Access Compliance Report Public Rights-of-Way (Curb Ramps)

Main Street: BROOKHURST_ST		Cross Street: PALAIS_RD		Location:	SW
ADA ID: RPAT211119093511	Ramp Type: Type 4 - Parallel	Initial Pass/Fail: Fail	Overall Compliance: No	Severity Score:	15
Codes/Mitigation Info/Possible Solution			Field Measurements/Component Compliance

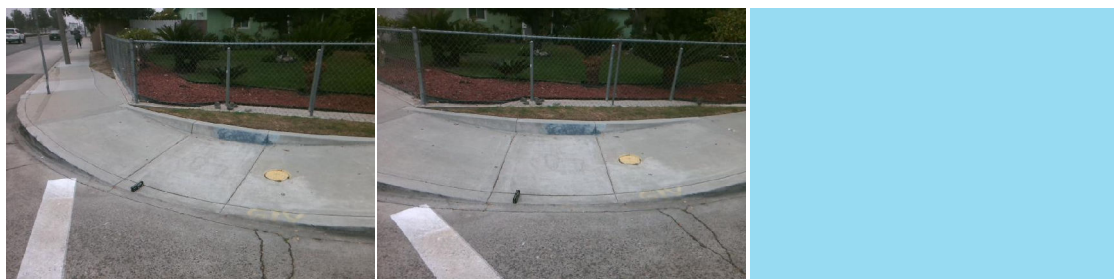
R304.3.2, STD 1115

Remove & Replace Curb Ramp With Two New Directional Ramps or Equivalent.
